SUBJECT: PUD Development Stage/Preliminary Plat Review: Prairie Gardens

1. Resolution PZ 20-008, Recommending the City Council Approve a Development Stage Planned Unit Development Plan for Prairie Gardens.
2. Resolution PZ 20-009, Recommending the City Council Approve a Preliminary Plat for Prairie Gardens.

Prairie Gardens Proposed Planned Unit Development

PRELIMINARY GRADING & DRAINAGE PLAN

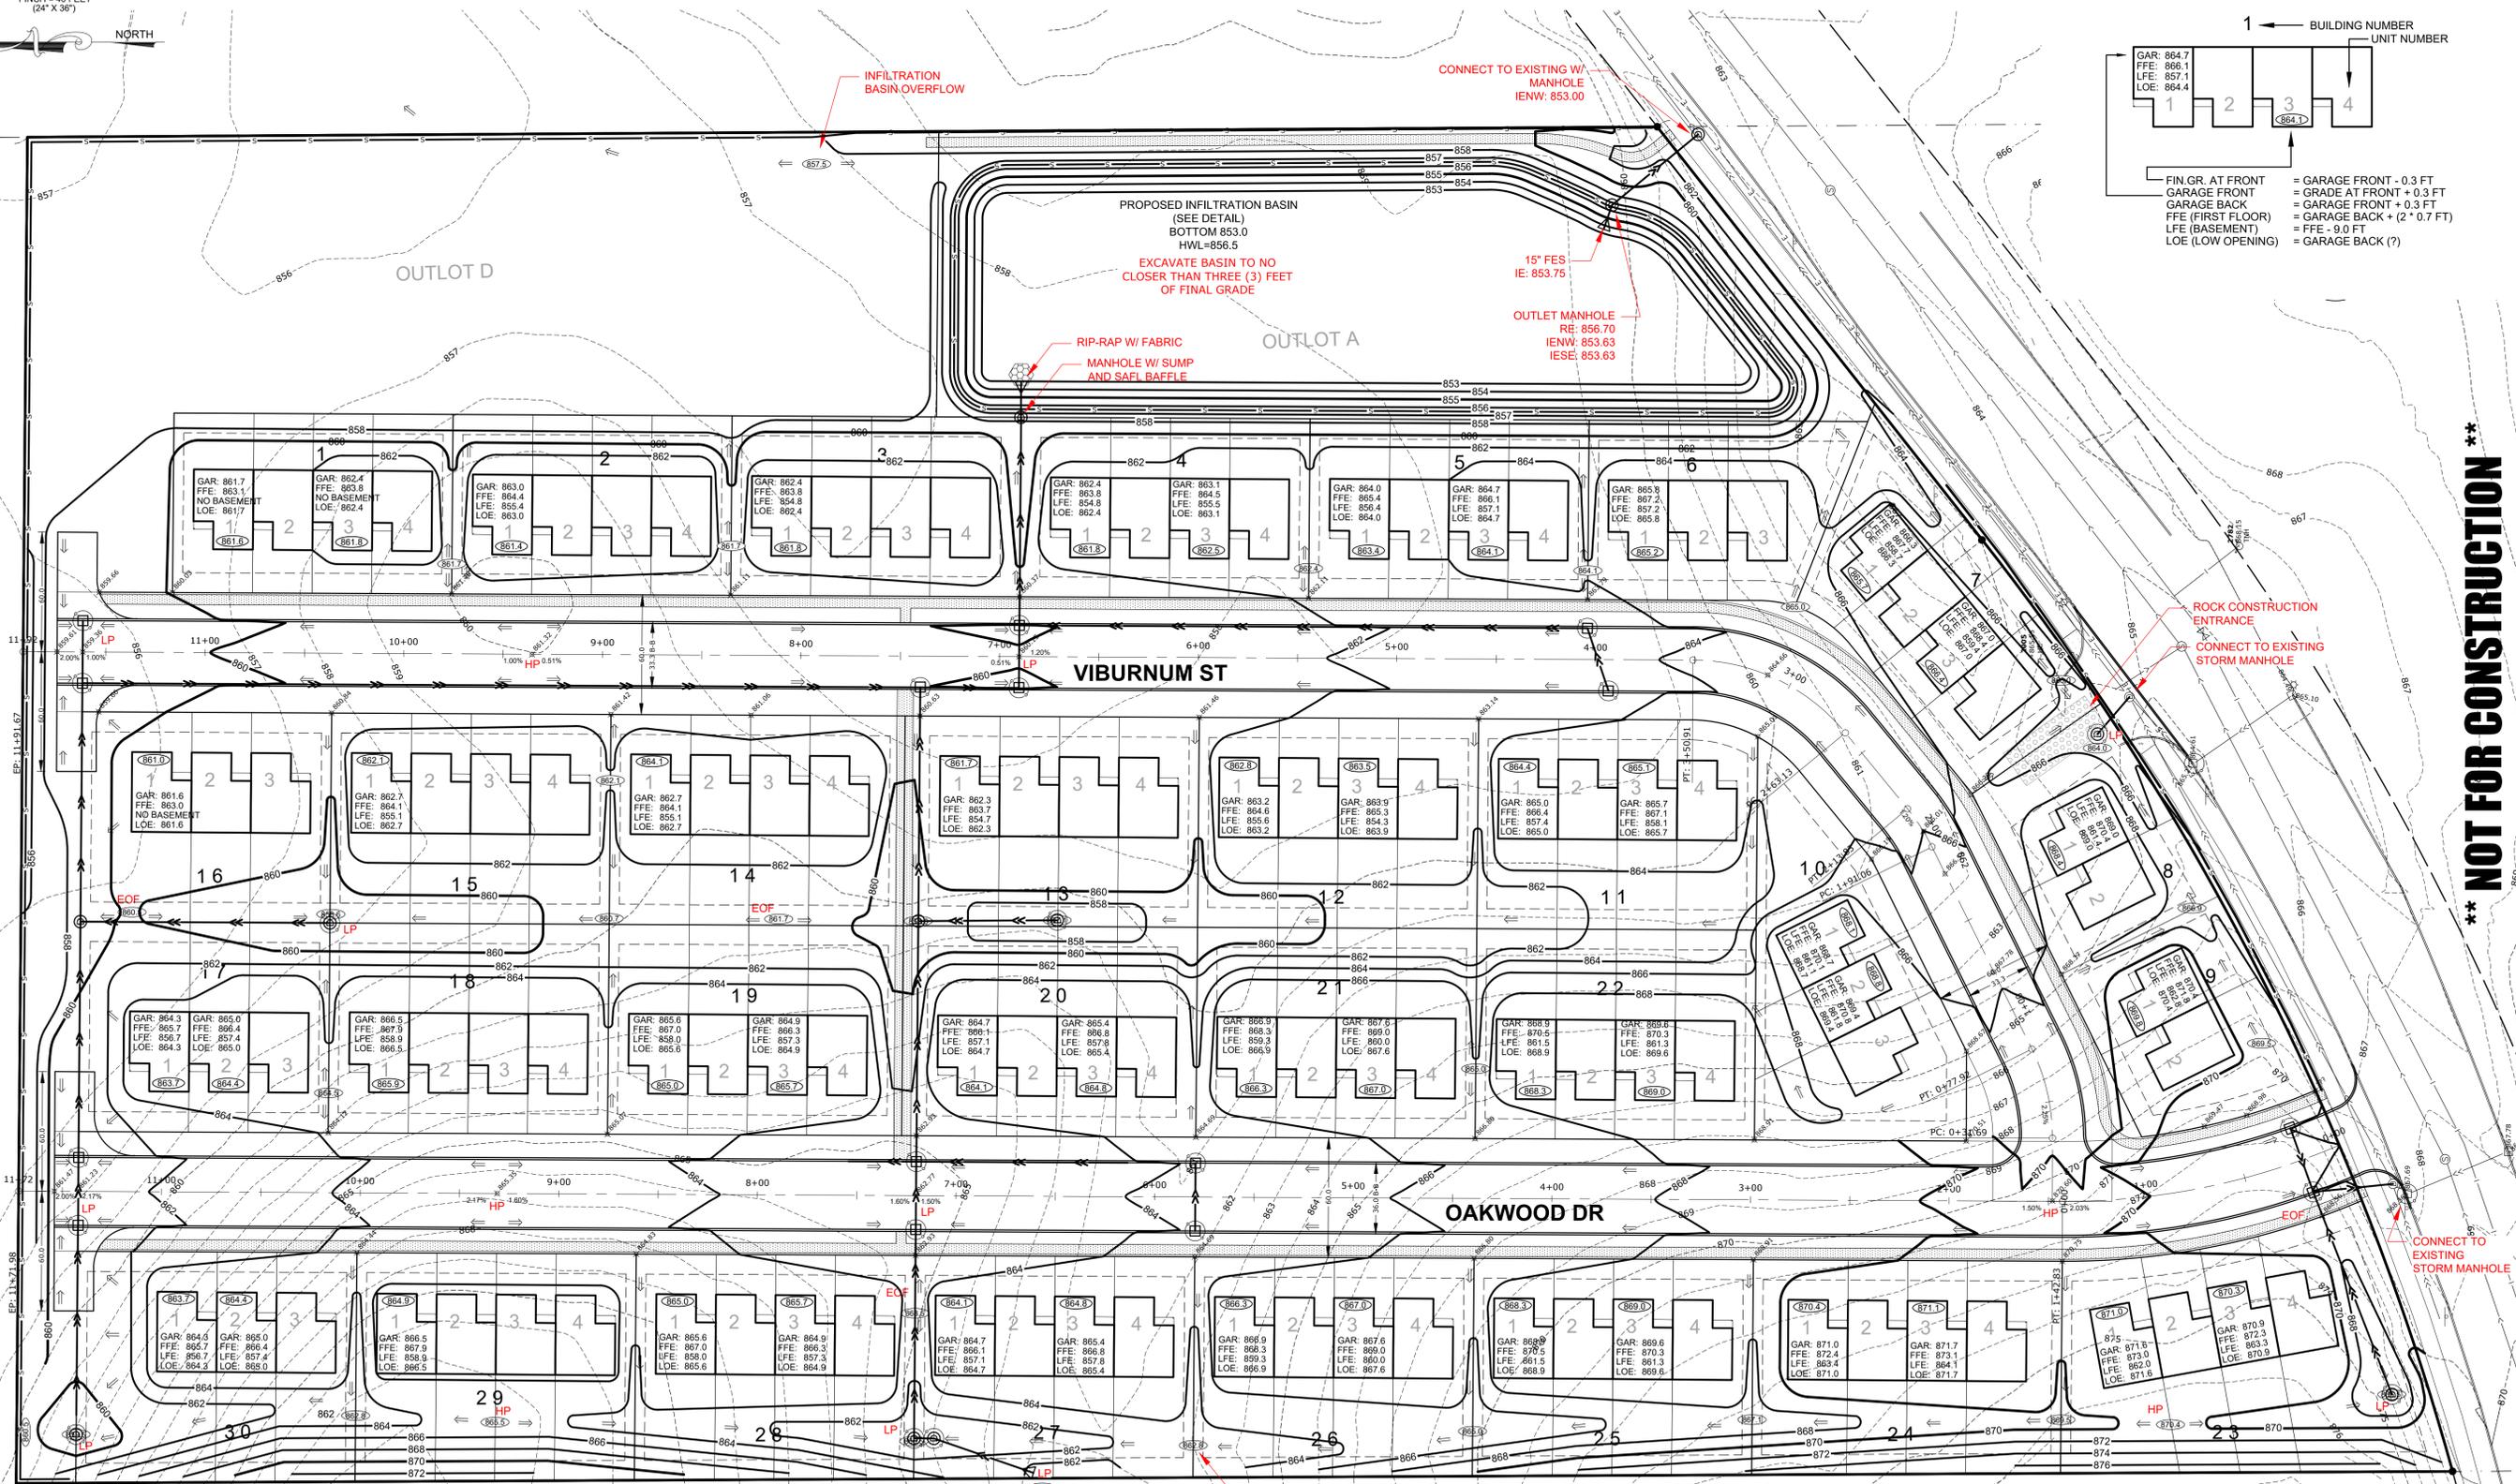
2. Provide EO elevations/locations for all storm water inlets located at low points, inlets, and basins.
3. Report HWL at each yard inlet/low point to ensure it remains in an easement.

4. Provide additional flow arrows as part of final grading plan.
5. Grading plan is developed for slab or full basements (including egress windows at grade). No look-outs or walk-outs are indicated and therefore will not be a permitted floor plan for construction.

- e. Label existing/proposed drainage figures to match HCAD nodal diagram.
 - f. Provide EO routing at each pond node in HCAD.
 - g. Include pipe routing for any necessary yard inlet to remain.

STORM WATER POLLUTION PREVENTION PLAN (SWPPP)

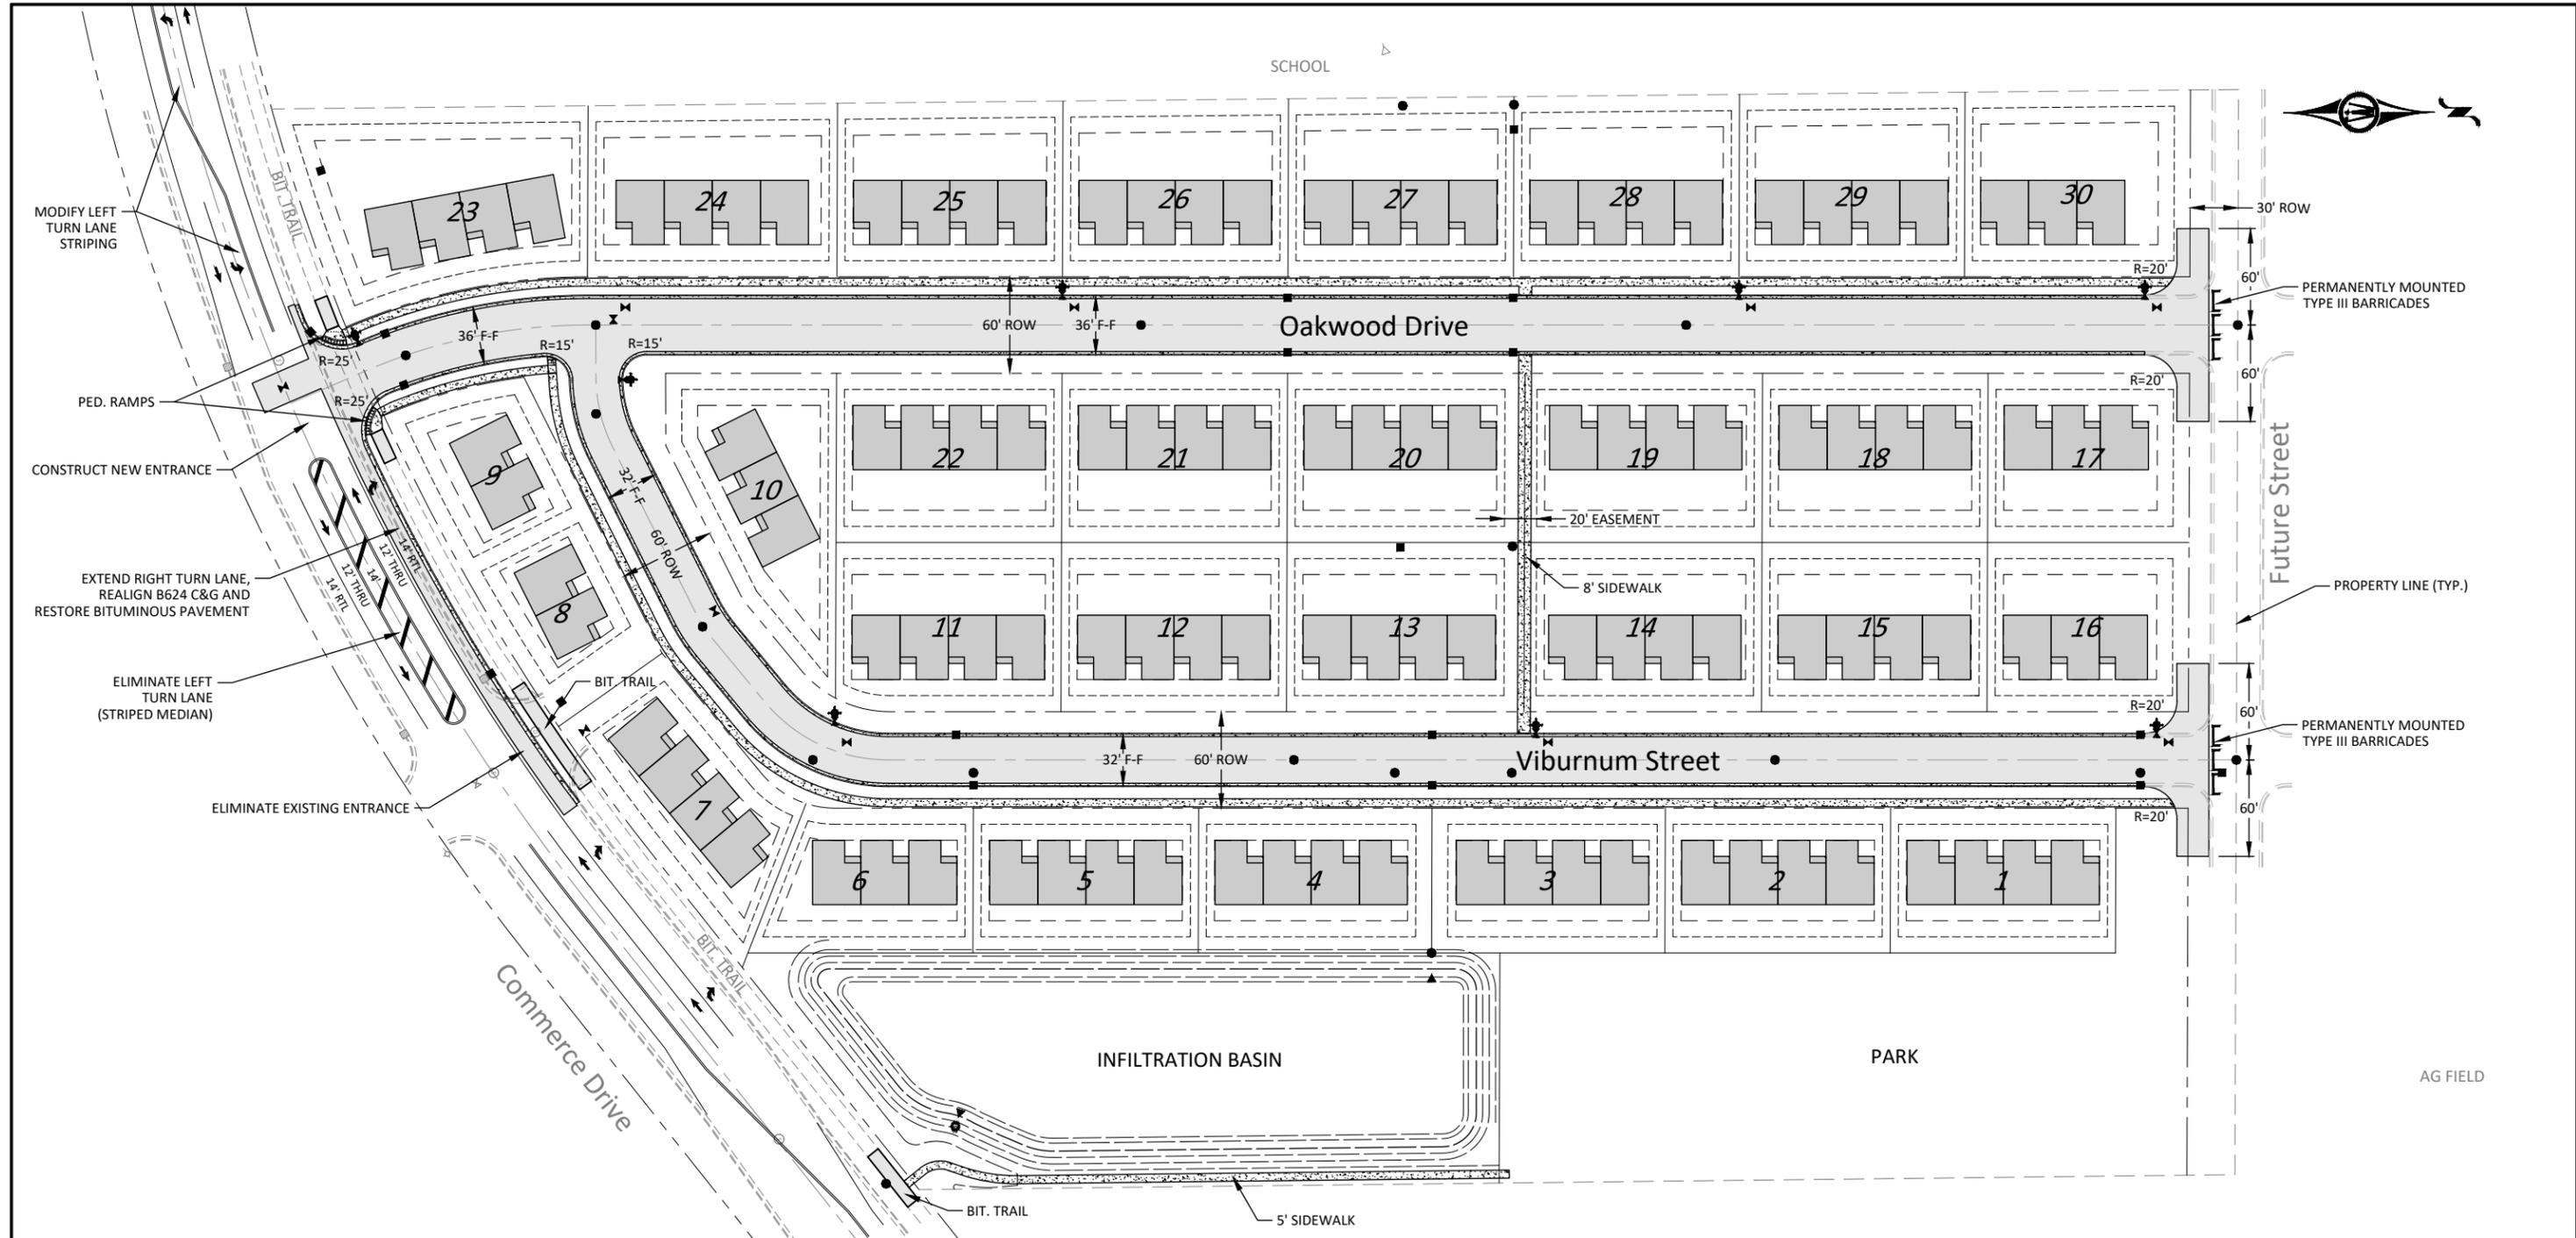
- j. Provide temporary sediment pond requirements and temporary pond outlet detail.
 - k. Correct minor inconsistencies in provided SWPPP document.
7. Consider alternative phasing to construct south half of property first rather than an east/west scenario. Several infrastructure benefits are worth evaluating.

FRONT ELEVATION

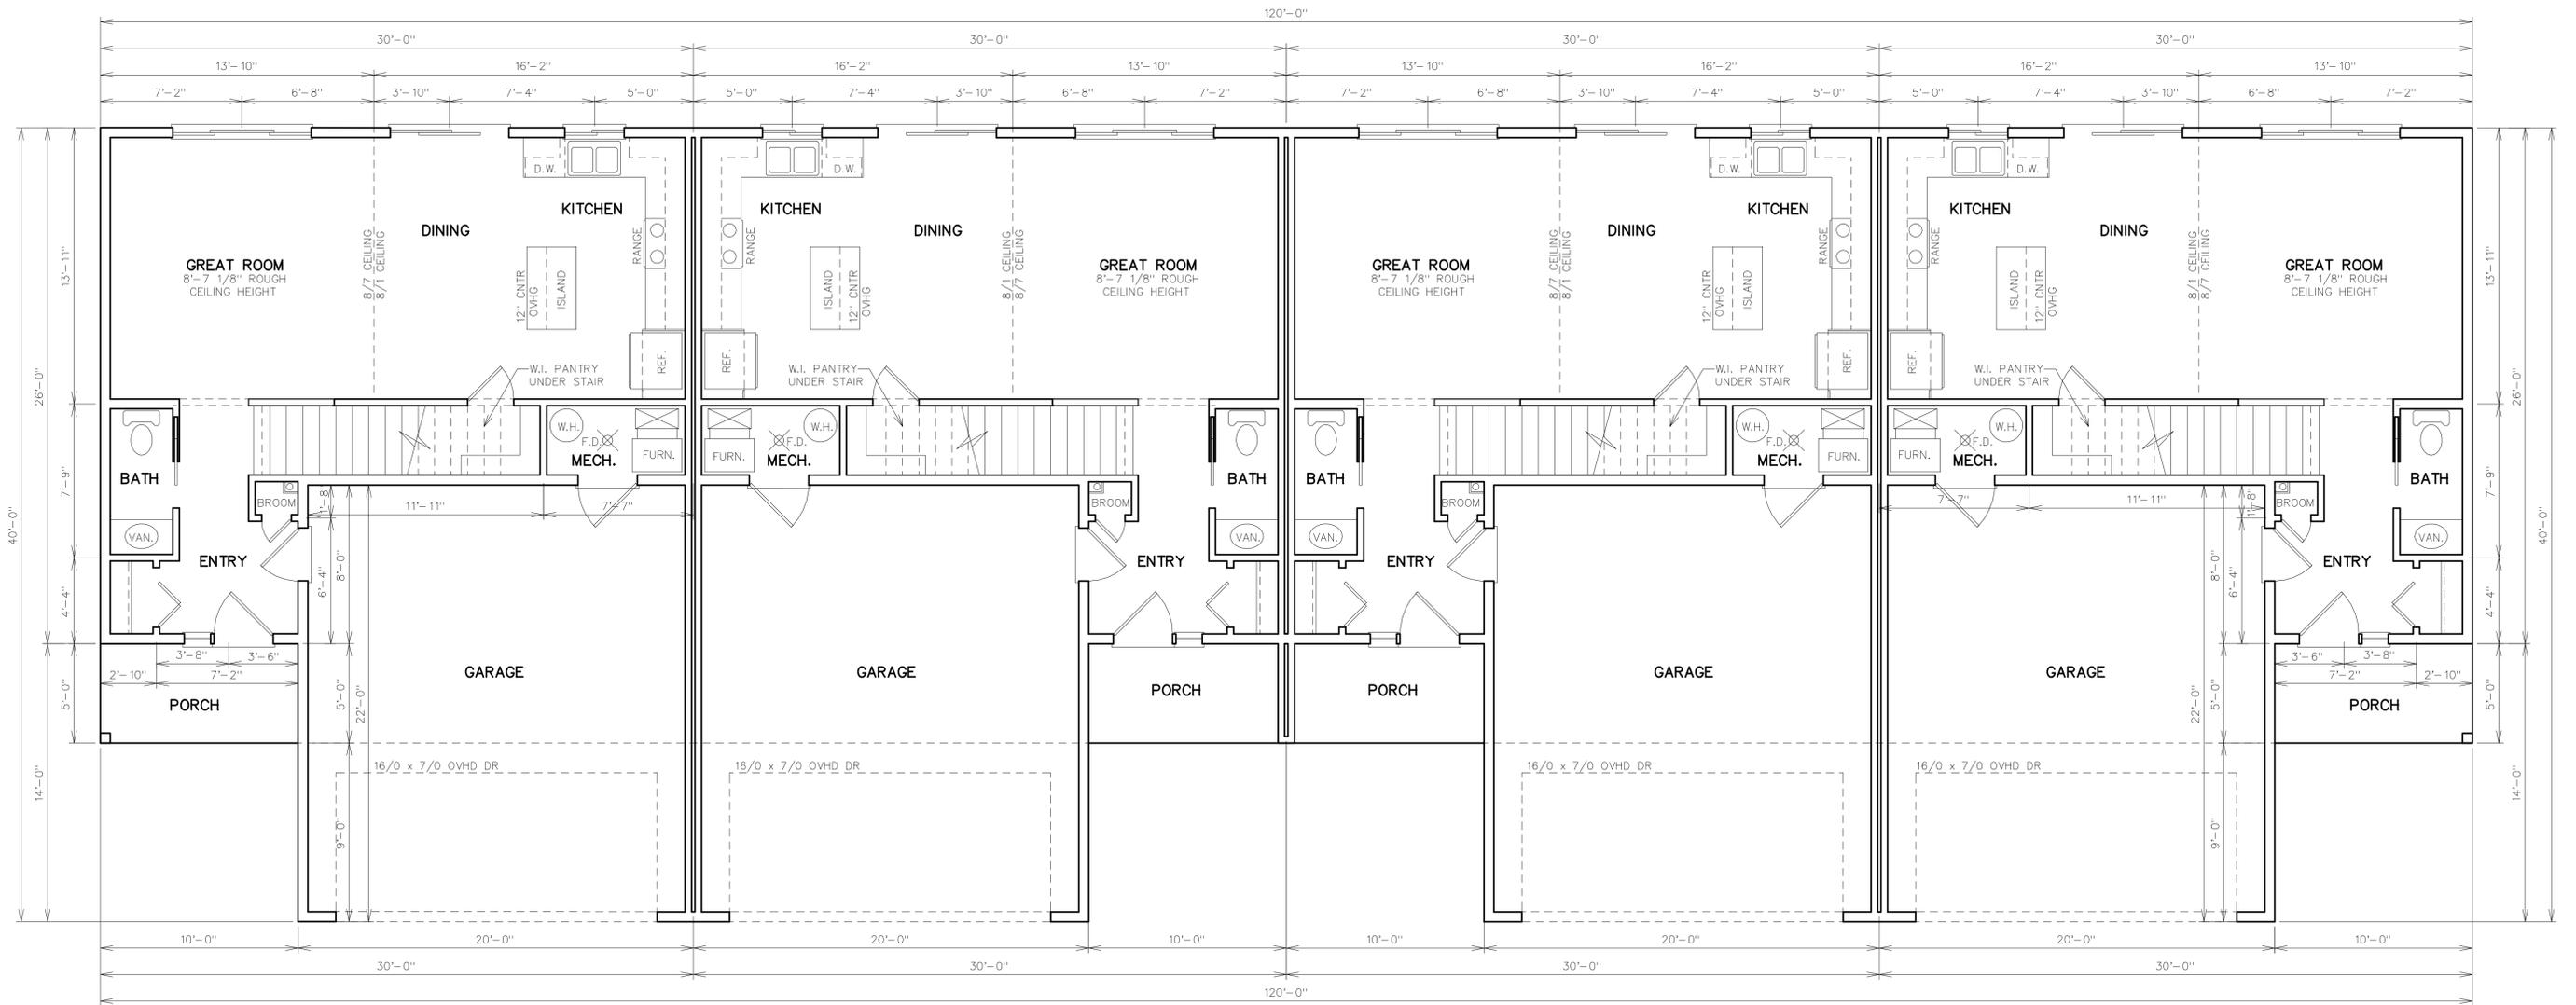
To increase livability and sales potential, the Developer should consider adding outdoor spaces such as patios or decks, especially in rear yards with physical or vegetative separation between outdoor spaces.
